August 21, 2015

Reference No. 311977

**Re: Response Letter  
Chevron Service Station 90076  
4265 Foothill Boulevard  
Oakland, California  
Fuel Leak Case No. RO0000427**

CHEVRON SERVICE STATION 90076  
4265 FOOTHILL BOULEVARD  
OAKLAND, CALIFORNIA  
**PROPOSED SOIL BORING AND  
MONITORING WELL LOCATIONS**

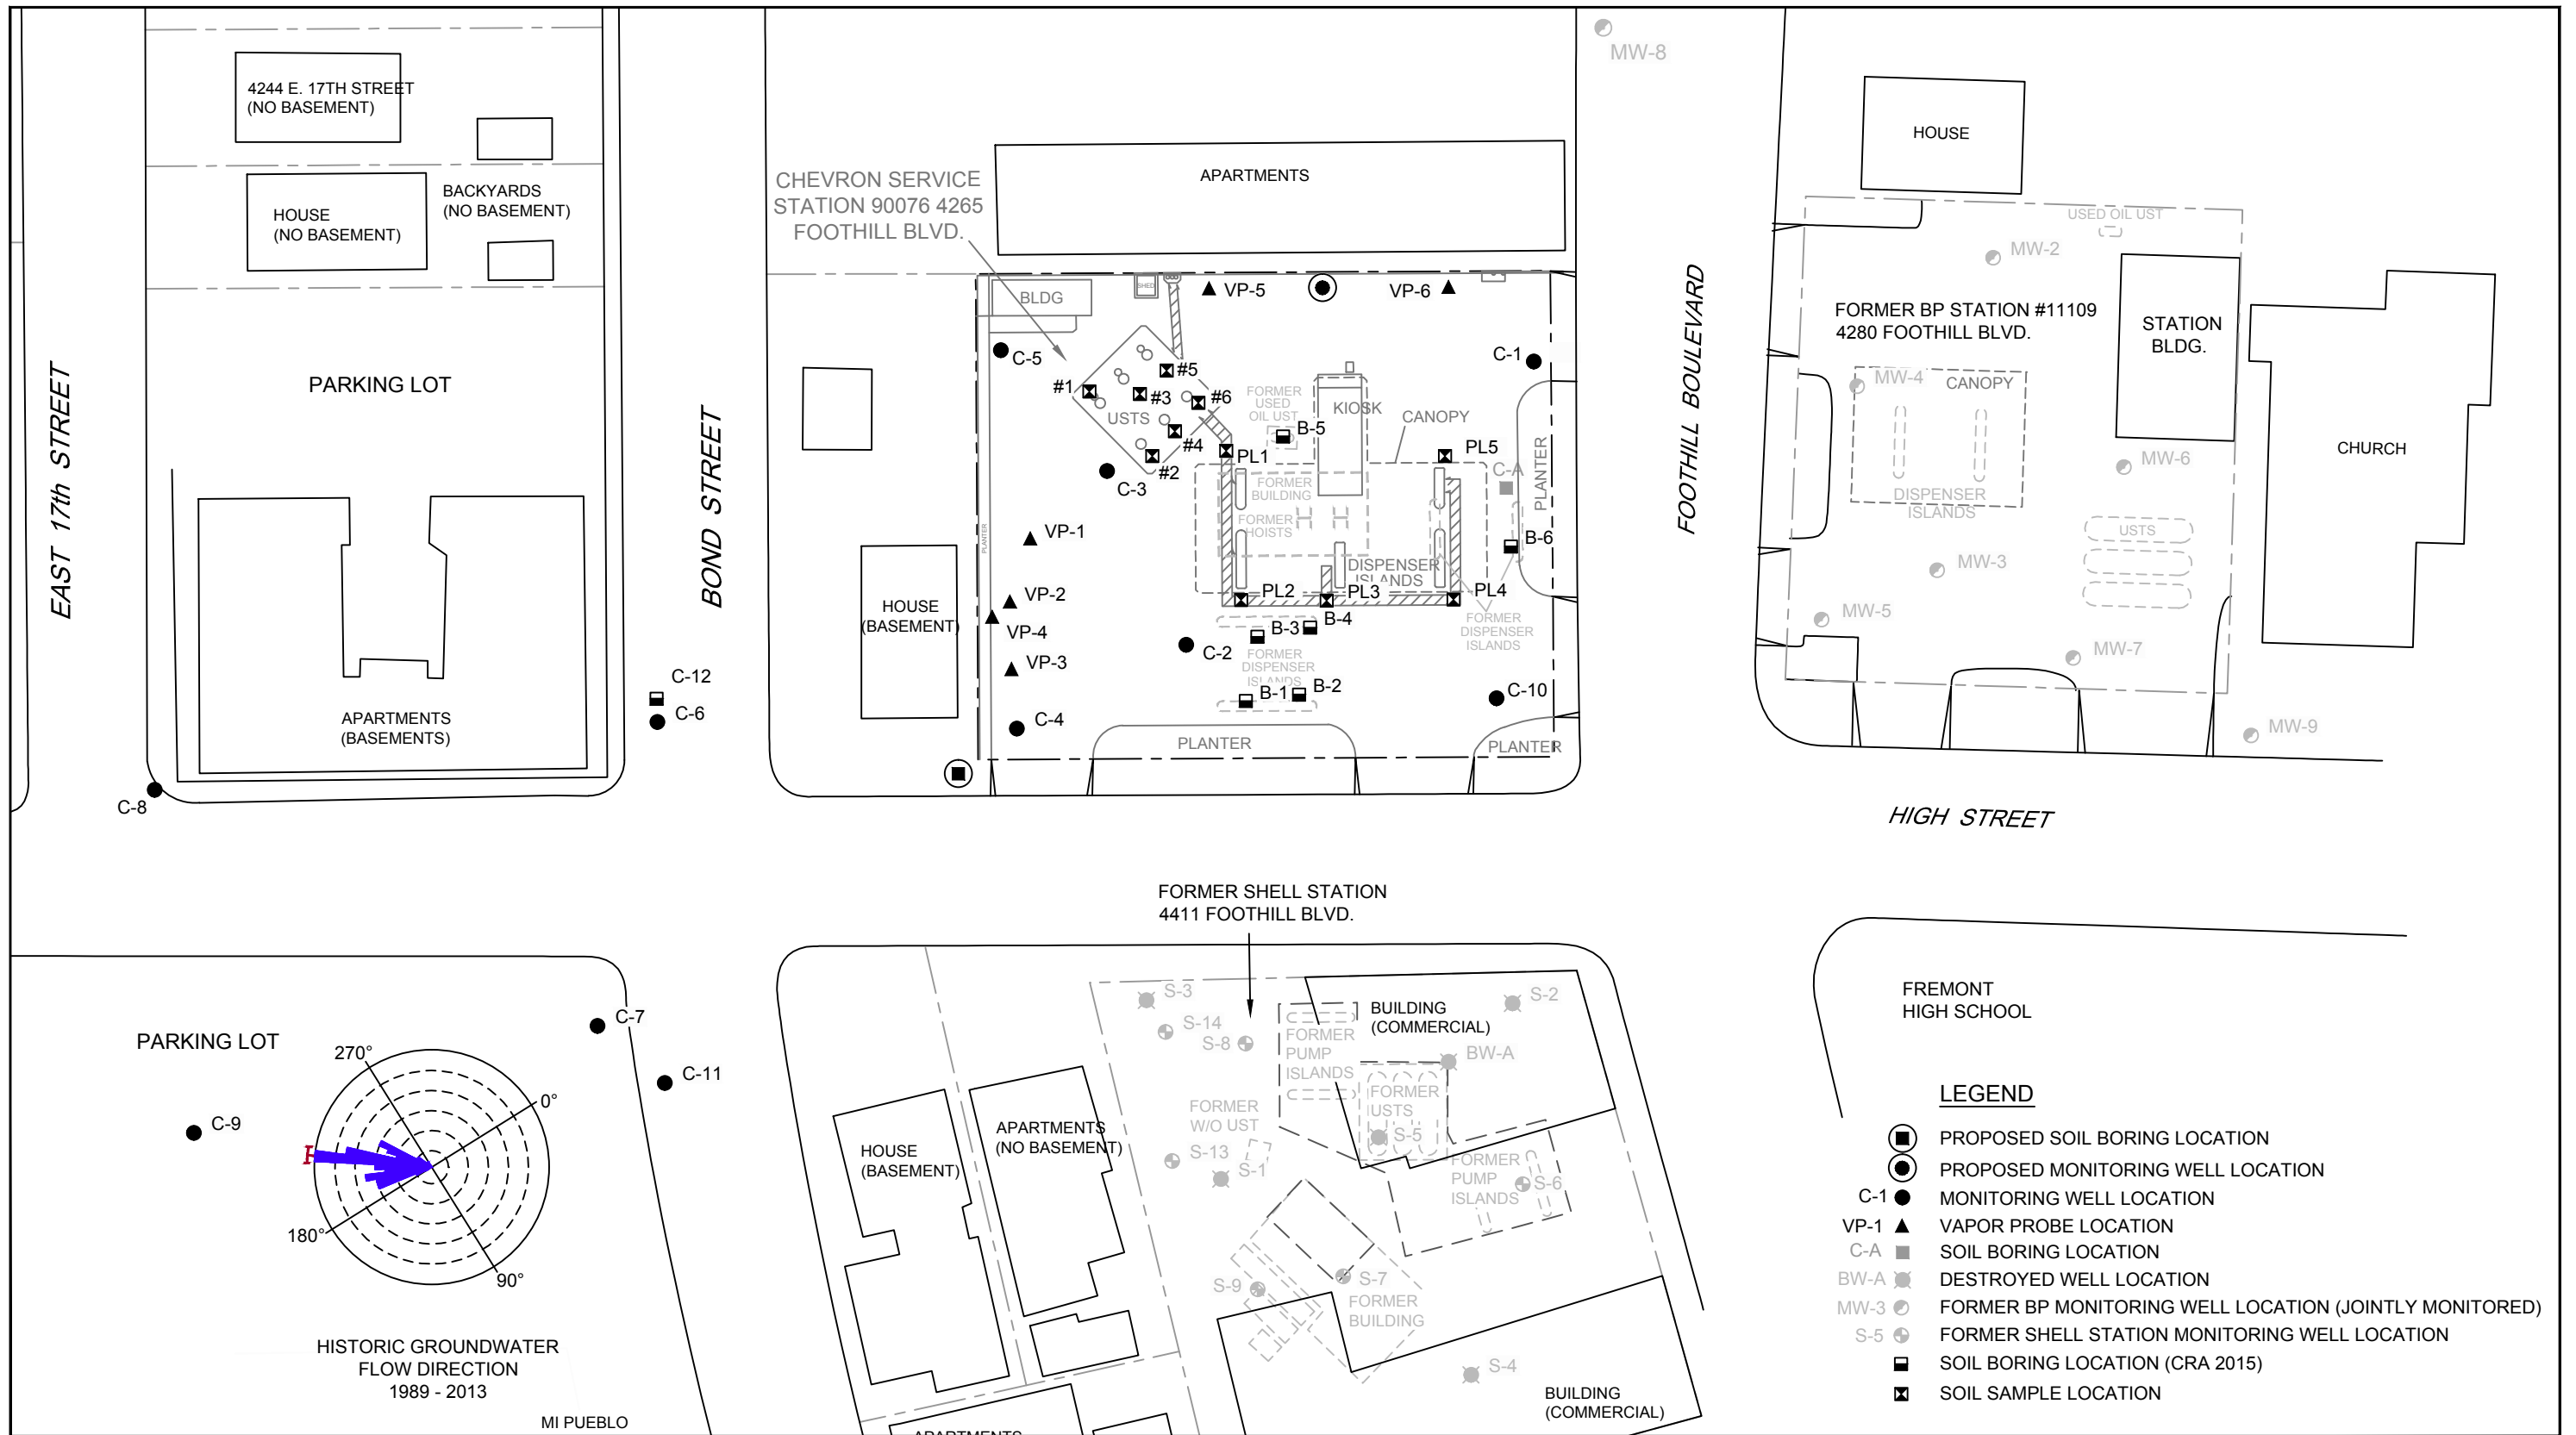
*ACEH states that the basement depth of the house, downgradient of the site has not been determined or documented; therefore the ACEH notes that it is uncertain if vapor probes VP-1 through VP-4 sufficiently evaluates the potential for vapor intrusion at a depth of 5 feet below the building foundation and that the vertical migration of vapor from groundwater to a basement does not appear to have been evaluated.*

3. *Offsite Direct Contact Evaluation*

GHD believes that VP-1 through VP-4 sufficiently evaluates vapor intrusion risk as groundwater is encountered at approximately 6 fbg as noted during the installation of VP-4 (Figure 2). Furthermore, based on depth to groundwater observed at the property boundary, it would not be possible to install a vapor probe below the basement foundation. Probes VP-1 through VP-4 are installed at approximately 5 fbg approximately 1 foot above where groundwater was encountered. As the probes are located 1 foot above groundwater, any hydrocarbons that could potentially volatilize from groundwater would be captured during the probe's sampling, due to the close proximity to groundwater. As the February 2015 sampling event results from vapor probes VP-1, VP-3, and VP-4 where below the Low Threat Closer Policy<sup>1</sup> soil vapor concentration levels, and therefore does pose an intuition risk.

GHD proposes to advance one boring, to approximately to 10 fbg in the vicinity of well C-4 (Figure 2) to further evaluate hydrocarbons in soil below 7.5 fbg. The boring will be advanced using the methods outlined in CRA's *Site Investigation Report, Updated Site Conceptual Model, and Work Plan* dated April 17, 2015 with the exception that the hand auger will be advanced 10 fbg instead 8 fbg, and soil samples will be collected at 5 and 10 fbg. GDH will proceed with the proposed scope of work upon receipt of written approval from ACEH. CRA will then obtain all the required permits, work to coordinate access to the proposed locations and schedule the subcontractors.
